Product Change Notification

Change Notification #: 117063 - 00
Change Title: Intel® Spare Drive Bays & Carrier Options
FXX35HSCAR2,
PCN 117063-00, Product Design,
3.5" Tool-Less Carrier Design Improvement
for 2.5" Drive Support
Date of Publication: July 12, 2019

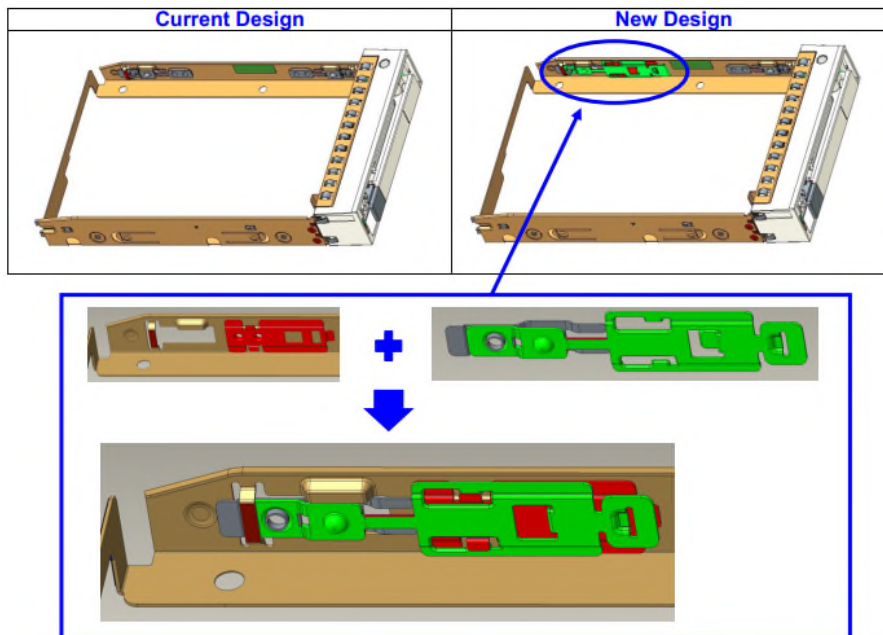
Intel is implementing an improvement on FXX35HSCAR2 3.5" tool-less drive carrier for 2.5" drive support, new rear spring (see image in green) and new spring holder (see image in red) attached to the tool-less drive carrier. Removing the rear spring of 3.5" tool-less carrier when Install 2.5" SSD drive, installing the rear spring to support 3.5" HDD.
